RE: McAtee Construction Co.
Riverside Pit, Permit # M-1976-056
Technical Revision 04 - Adequacy Response

On behalf of my client McAtee Construction Co., I am responding to your first adequacy review letter received on August 18, 2014. The following answers to the adequacy questions are based on the consensus we reached during the October 1, 2015 site inspection. I have included your review points that need to be addressed in the same order as presented in the letter so the question and answer will be in the same document for easy reference.

RECLAMATION PLAN MAP - TECHNICAL REVISION MAP 5-15A

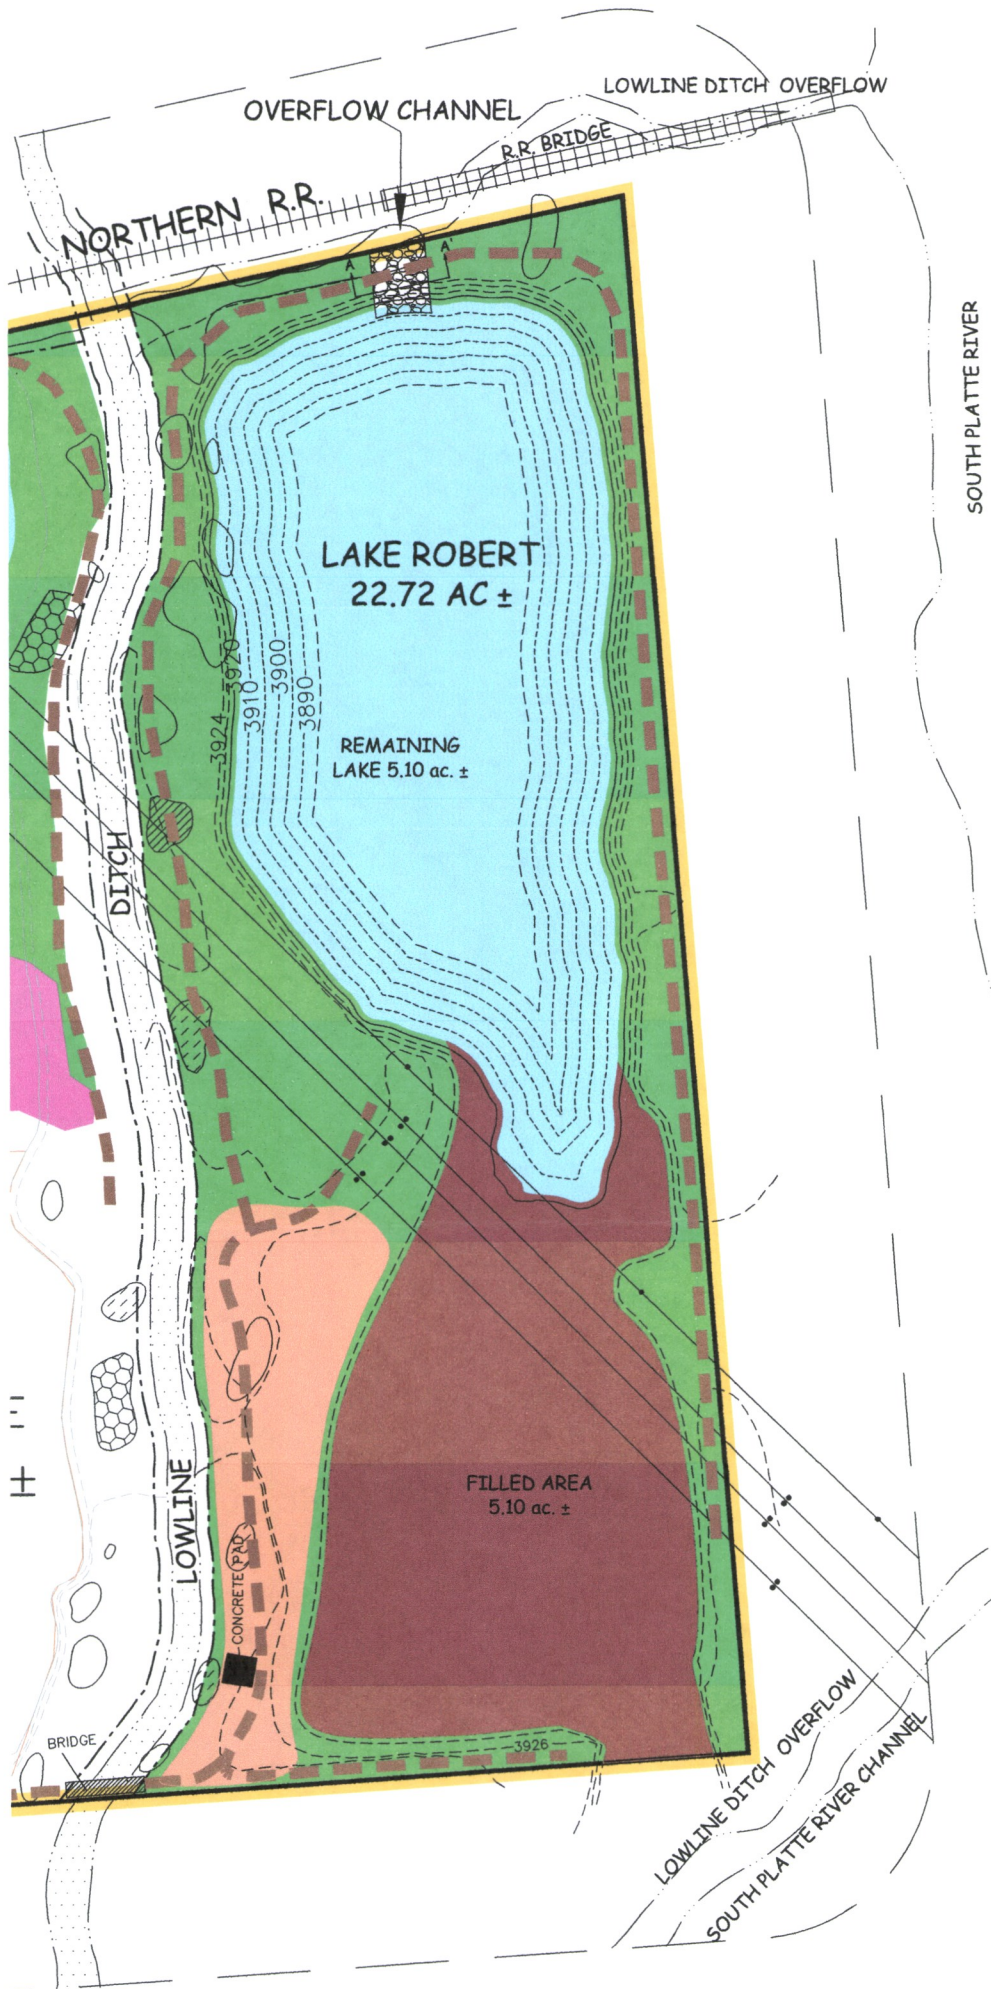
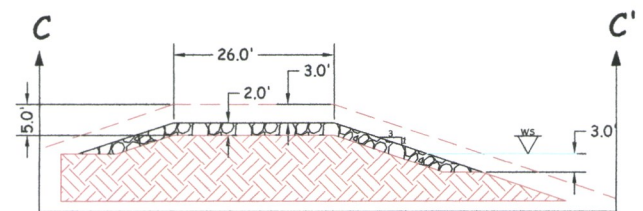
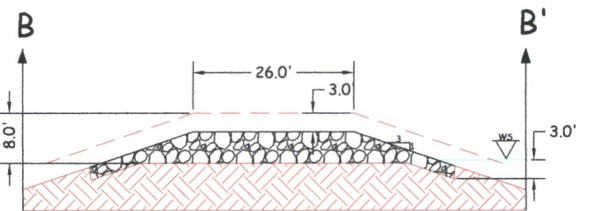
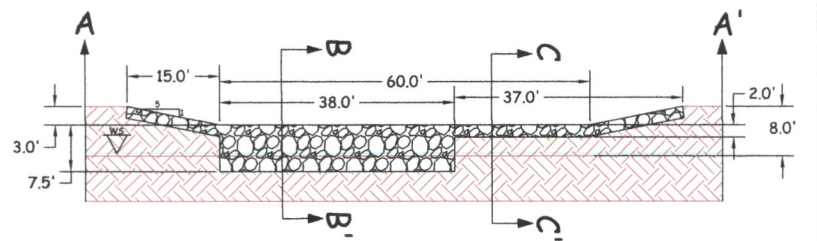
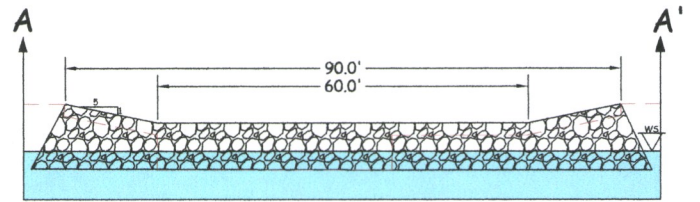
3. The Reclamation Plan Map submitted with the Technical Revision application did not display the signature of the registered land surveyor, professional engineer, or other qualified person who prepared the map; did not label the permit boundary; did not display a scale; and thereby failed to satisfy the requirements of Rules 6.2.1(2)(b), (d) and (e). The contour lines on the map were not legible and did not illustrate the physical appearance of the reclaimed lands, and thereby failed to satisfy the requirements of Rule 6.4.6(a).

Please submit a Reclamation Plan Map which not only satisfies the requirements of Rules 6.2.1 and 6.4.6, but also delineates and labels the following features:

- Lake Robert, with contour lines sufficient to illustrate the proposed banks, the new seasonal average water line, and the
- Lowline Ditch,
- Entire length of the Lowline Ditch return channel(s) (new, abandoned, and the second return channel located just north of Lake Robert), and the
- South Platte River

Your right. It was a sketch map I have revised the Technical Revision map to show current conditions so it meets the rules requirements. Note that much of the South Platte River is more then 200 feet from the permit area but I have added it as appropriate. I also revised the map to show the current filling conditions within Lake Robert and it may be necessary to revise this map from time to time until filling ends. We propose using the Annual Report Map to update and show the changes during the 5 year monitoring period.

If the Operator intends on the revising the Reclamation Plan to allow for flood-water flows to pass through the Lake Robert area, the Division will require a designed structure to adequately accommodate flows and to protect the shoreline at the inlet and outlet of the lake. Please submit designs for these structures for review and approval.

Attached to the new Technical Revision map are a series of sketches for the conceptual plan we discussed. They are for reinforcing a section of the north bank to allow the water to leave Lake Robert during highwater events. The existing cut point is the low point along the north bank so at this point an armored spillway will be constructed to allow free passage of the overflow water that enters the mine. This involves filling the existing cut area with large pieces of broken concrete to within three (3) feet of the top of the existing bank and expand the lower outlet area to 60 feet wide. The armoring will be done on the inside and outside banks with the same material used to fill the cut. The armoring will be a minimum of 2 feet thick and on the south facing slope it will be placed approximately 3 feet below the existing water level.
